PLANNING COMMISSION AGENDA
Thursday, December 15, 2016
6:30 p.m.
Coon Rapids City Center
Council Chambers

Subject: PC16-28 Site Plan, Building Addition, 8960 Evergreen Blvd, Welsh/Genesis Architecture

SUBJECT: American Preclinical Services – 8960 Evergreen Boulevard
Proposed Site Expansion

LANDSCAPE PLAN
 CITY OF COON RAPIDS, MINNESOTA

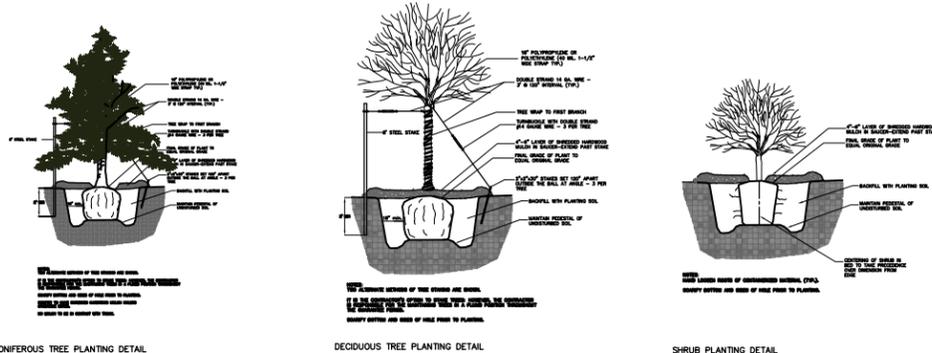
The landscaping along Evergreen Boulevard should be updated so that it is in compliance with the approved plan. The landscape plan should be revised to accurately reflect what is currently in place and what will be removed as a result of construction. The approved plan included seven overstory trees and 23 shrubs. The landscaping along 90th should be brought into compliance with the current standards. Nine street trees and 70 shrubs are required. The plan shows four ornamental trees, those should be changed to overstory trees, and five additional trees are needed. The plan also shows 28 shrubs; 42 additional shrubs are needed.

Open space requires two overstory trees, two evergreen trees, four ornamental trees and 56 shrubs. The plan should be revised to comply with those requirements. The landscaping around

the pond includes sumacs, lilacs and six evergreen trees. These plantings will also screen the loading area. Two overstory trees are provided in each parking lot island and landscaping is provided on the peninsulas. All landscaped areas should be irrigated.

**GRADING, DRAINAGE &
 EROSION CONTROL PLAN
 CITY OF COON RAPIDS, MINNESOTA**

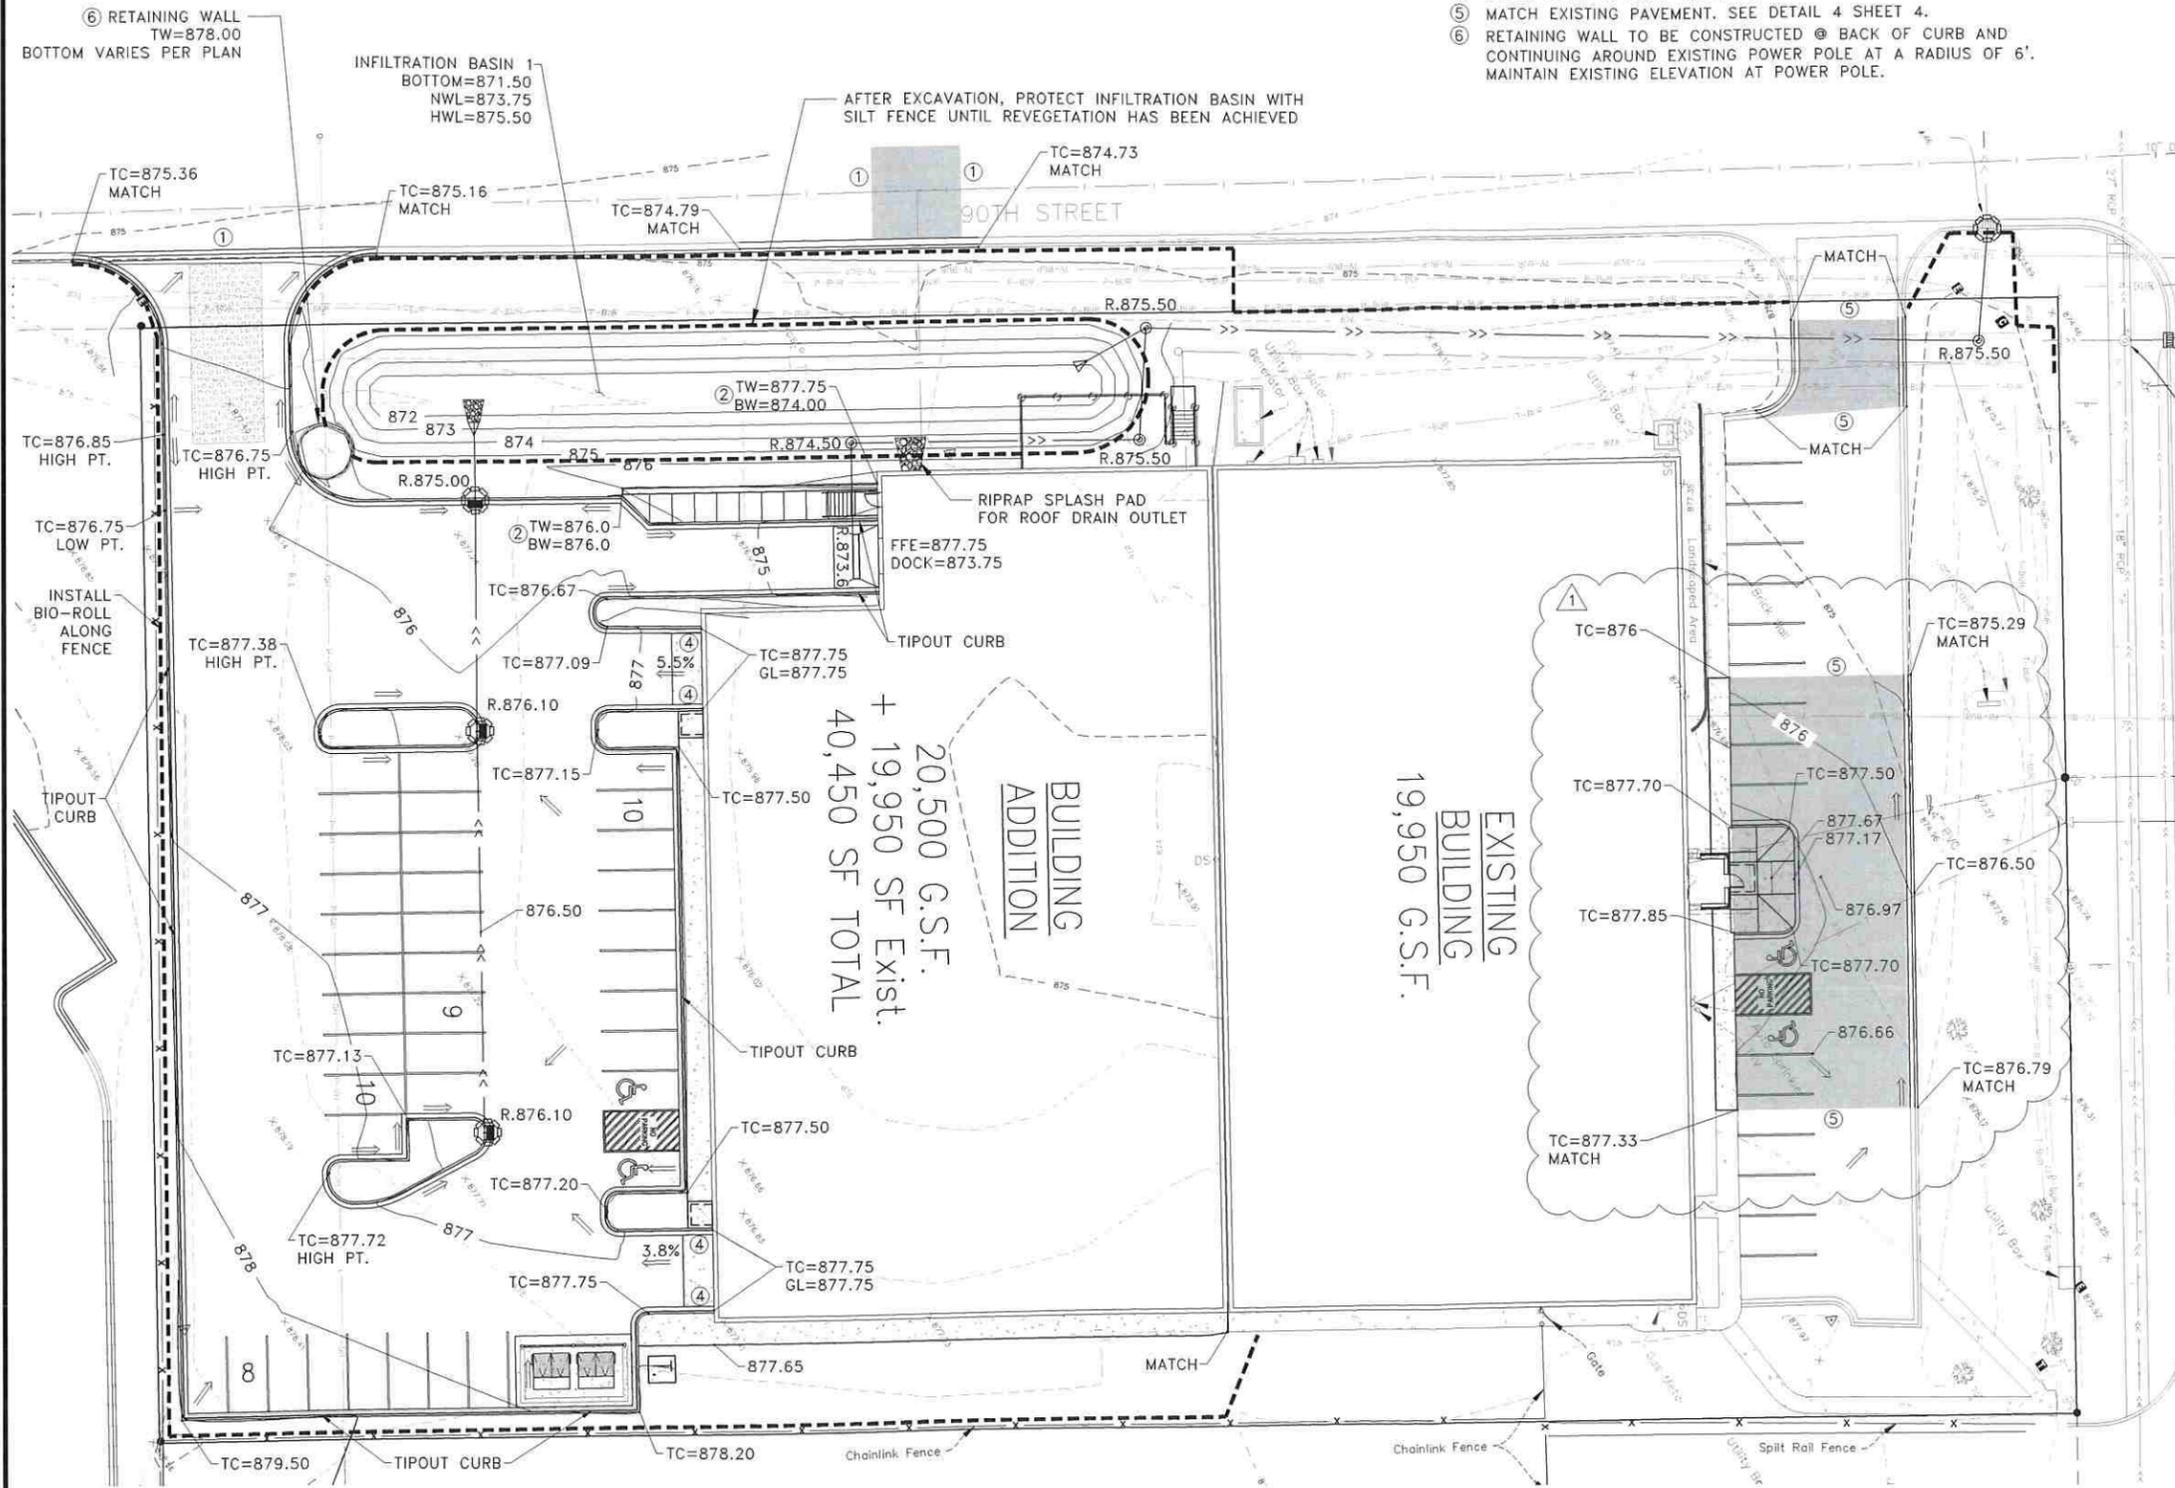
- Truck turning templates shall be provided that show the largest vehicle anticipated to be accessing the proposed building expansion area.
- Several sidewalk grades are shown steeper than 5%. Provide verification this slope design meets ADA standards for sidewalk slopes.

- The City is concerned about having the proposed 6-inch water stub off 90th Avenue located below the infiltration basin, and using vertical bends to achieve proper bury depth. The City would prefer the infiltration basin be re-designed as a two cell system connected by a small PVC pipe, which would then provide normal cover depths, and eliminate the need for vertical bends on the proposed water stub. If the basin re-design cannot be done, 4-inch insulation shall be required at the vertical offset if 7.5-feet of cover is not achieved.

- Please identify where reference note #3 applies to.
- Please provide a copy of the geotechnical report prepared by NTI. The soils within the Evergreen business park are generally not conducive to infiltration. Drain tile will most likely be required to meet draw down requirements.

- Recommend connecting the concrete sidewalk that dead ends at the east corner of the property to the new City sidewalk located on the west side of Evergreen Boulevard. An expansion joint must be placed at the point of connection to City sidewalk.

- The applicant shall coordinate with Xcel Energy to relocate the existing street light along 90th Avenue to continue to be close to the proposed entrance/exit to the rear parking lot.
